S4.55 MODIFICATION:
SCHEDULE OF CHANGES

PROJECT:
NEWPORT RESIDENTIAL FLAT BUILDING

54 - 58 BEACONSFIELD STREET NEWPORT

S4.55 APPLICATION

1 | S4.55_BASEMENT 01_STORAGE
1 : 200

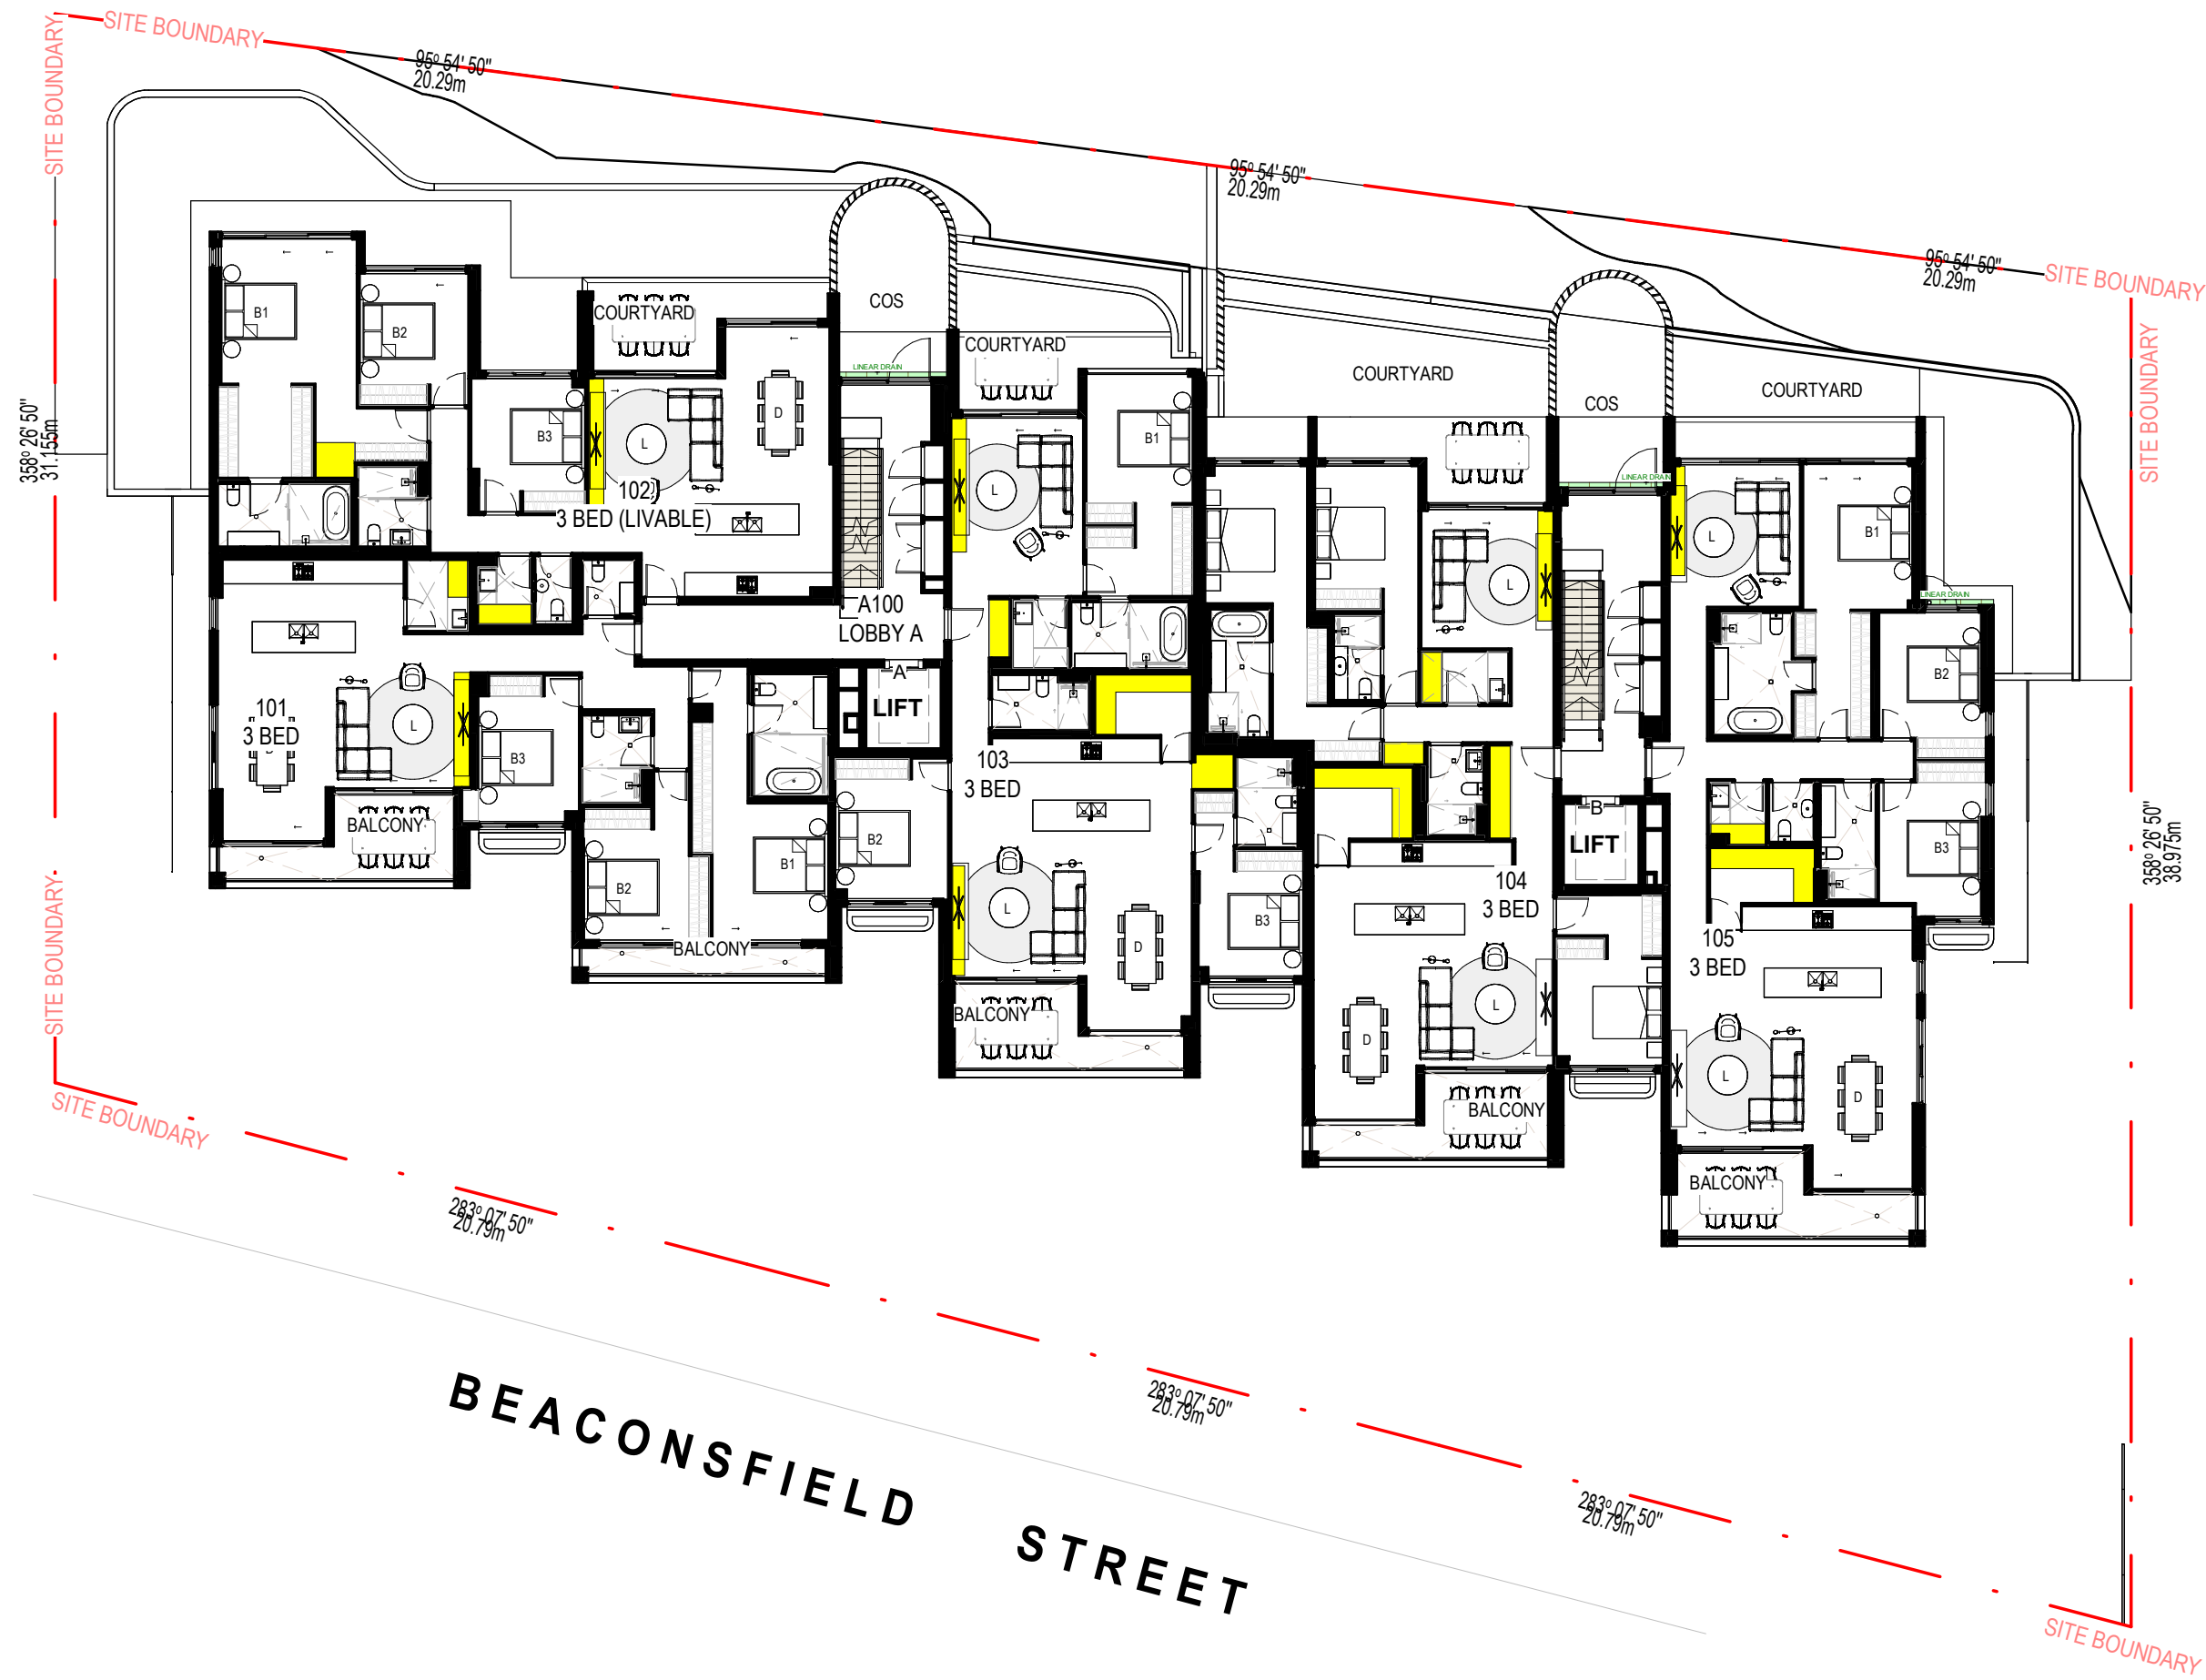
- Storage Rooms converted into Cellar Rooms
- Back of House Stair Revised with Platform Lift for Improved Accessibility
- Level 01 Courtyards pavement revised to improve water and weatherproofing
- Unit 204 Ensuite Revised
